PJM Interconnection, L.L.C.
Docket No. ER23-1648-000

Issued: June 15, 2023

Re: *PJM Interconnection, L.L.C., Docket No. ER23-1648-000*
Amendment to ISA and ICSA, SA Nos. 6354 and 6355; Queue No. AD1-130
(amend)

ISA/CSA Schedule B (Amended)

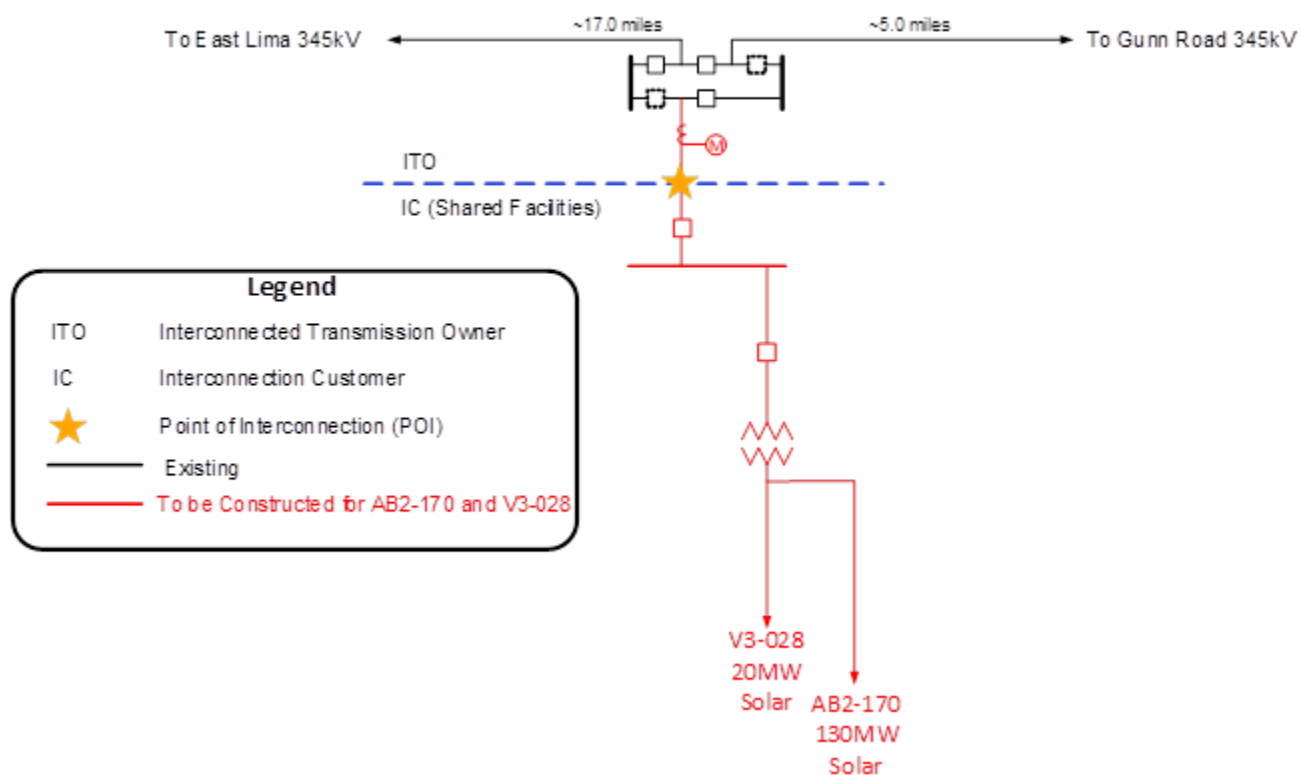
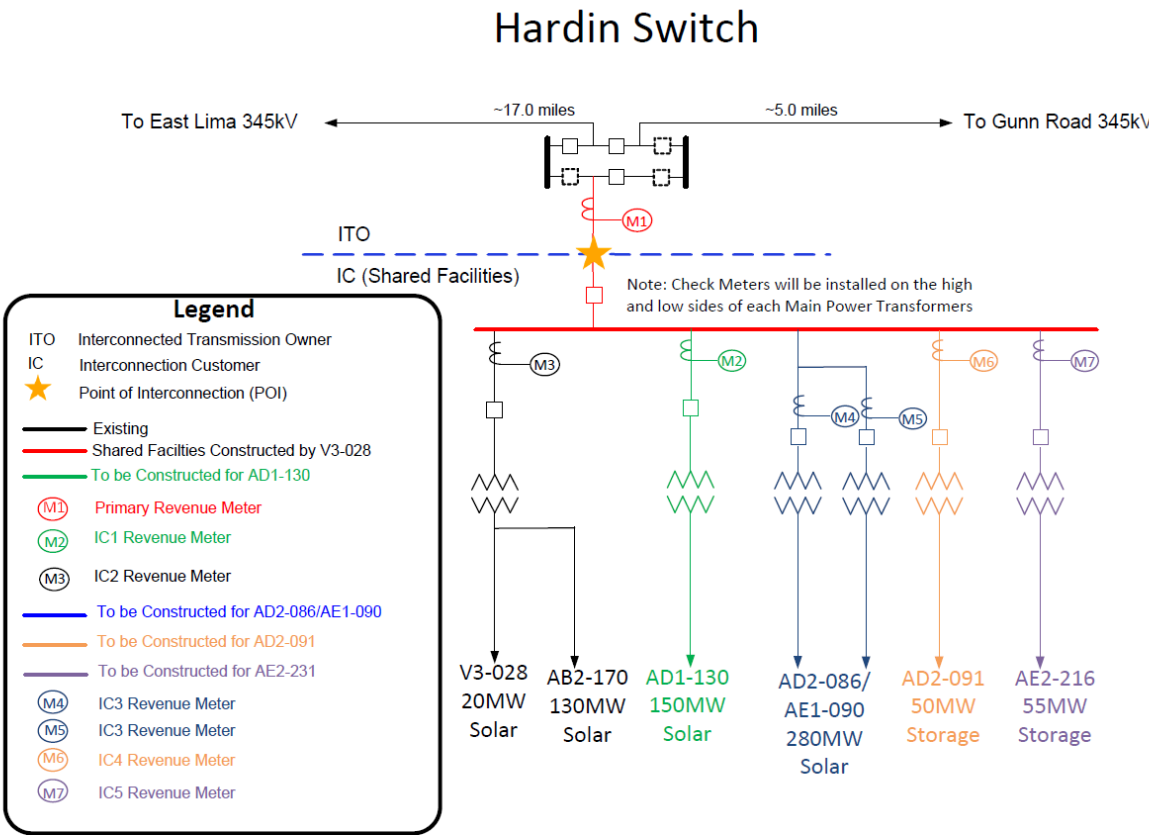
The Amended AD1-130 Agreements also include changes to the single-line diagram and metering requirements.⁹ Schedule B to the Amended AD1-130 Agreements includes an updated single-line diagram that reflects three additional Interconnection Customers behind the Point of Interconnection.¹⁰ Schedule C to the Amended AD1-130 ISA also includes revised metering language that explains the additional metering required to accommodate additional Interconnection Customers behind the Point of Interconnection. Schedule C also replaces nonconforming language regarding Hardin II’s metering equipment responsibilities with the following:

The Point of Interconnection is the first structure outside of AEP’s Hardin Switchyard (such structure being located in Interconnection Customer’s 34.5-345 kV Collector Substation) with the Interconnected Transmission Owner owning the first span of conductors including the optical (fiber) ground wire out of its station, and the Interconnection Customer and those entities listed in Table 1 of Schedule F under “Associated Interconnection Customer,” co-owning the first structure.
